Subject: MHI's Second Responses to US-APWR DCD RAI No.234

Response to Request for Additional Information No. 234-2040
Revision 1

US-APWR Design Certification

RAI NO.: NO. 234-2040 REVISION 1
SRP SECTION: 06.05.02 – CONTAINMENT SPRAY AS A FISSION PRODUCT CLEANUP SYSTEM
APPLICATION SECTION: 6.5.2
DATE OF RAI ISSUE: 2/26/2009

Figure 06.05.02-1 Variation of recirculation water pH with time

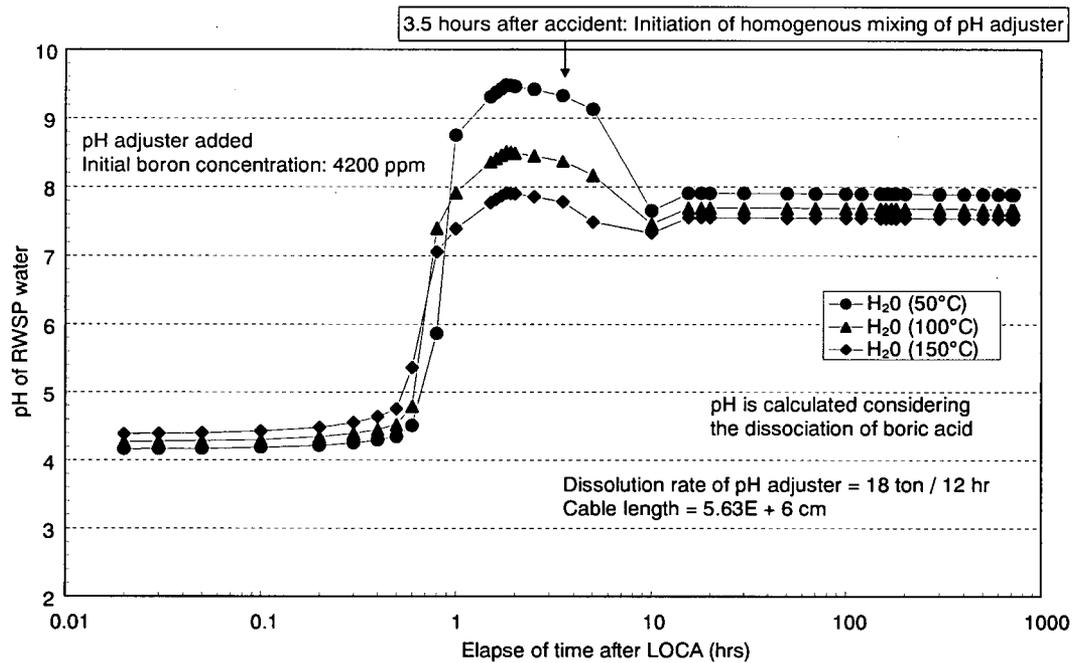
- a. Under DBA conditions, how long does it take for the RWSP water to reach a pH of 7 due to dissolution of NaTB?
- b. What is the dissolution rate of NaTB?

The DCD states that sodium tetra-borate decahydrate (NaTB) is added to the spray/sump solution to raise the pH for iodine retention. The mechanism of addition is that baskets of NaTB are placed in the containment where spray water will fall on them, dissolve the NaTB, and drain back into the sump (RWSP). As configured, only a few of the sprays near the outer periphery of the containment will fall into the NaTB baskets (Figs. 6.3-10 and 6.3-11). The DCD (6.3.2.2.5) states that dissolution time for all NaTB is 12 hours, although no calculation is given. This seems to contradict the SRP 6.5.2 Acceptance Criterion II.1.G (p. 6.5.2-5), which says that a pH of 7 should be achieved by the onset of the spray recirculation mode.

d. The pH variation with time calculated considering factors described below that contribute to the recirculation water pH after an accident is described in aforementioned Figure 06.05.02-1.

- a. The NaTB contained in baskets is dissolved in 12 hours. Therefore, if it is expected that re-circulating water is buffered by base of NaTB solution only, it takes longer than 12 hours after

the occurrence of an accident for re-circulating water to reach a pH of 7. However, cesium is released from damaged fuel, and released cesium (CsOH in re-circulating water) raises a pH for re-circulating water. As a result, a pH for re-circulating water reaches to 7 within about 1 hour.

The contribution due to generation of carbonic acid (H₂CO₃) by dissociation of dissolved carbon dioxide was omitted since carbonic acid is a weak acid and the contribution is minor. Figure 06.05.02-1 shows the calculation result of the recirculation water pH variation from the initiation of dissolution of pH adjuster (NaTB) at 3.5 hours after an accident to complete dissolution at 15.5 hours after an accident considering the dissolution delay of pH adjuster (NaTB) to recirculation water.

According to Figure 06.05.02-1, the recirculation water pH increases with the transition of time after an accident and reaches pH>7 at 0.8 hour after an accident. It is considered that this result was obtained since the contribution by release of alkali (CsOH) was higher than the contribution by (initial) contained boric acid immediately after LOCA and the contribution by generation of acid (HI, HCl, HNO₃) after an accident. The increase margin of pH decreases after that point since it is considered that the contribution by generation of acid (HNO₃, HCl) increases due to radiolysis. The pH gradually decreases to the point around 7 immediately after the addition of NaTB since the dissolution amount is small but pH>7 is maintained after NaTB is completely dissolved.

The calculation result of Figure 06.05.02-1 shows that the recirculation water pH at the time when the pH adjuster was added (3.5 hours after an accident) is higher than 7, which means that dissociation of boric acid cannot be ignored. Hence, the recirculation water pH of Figure 06.05.02-1 is calculated using the expression (06.05.02-2) considering the dissociation of boric acid.
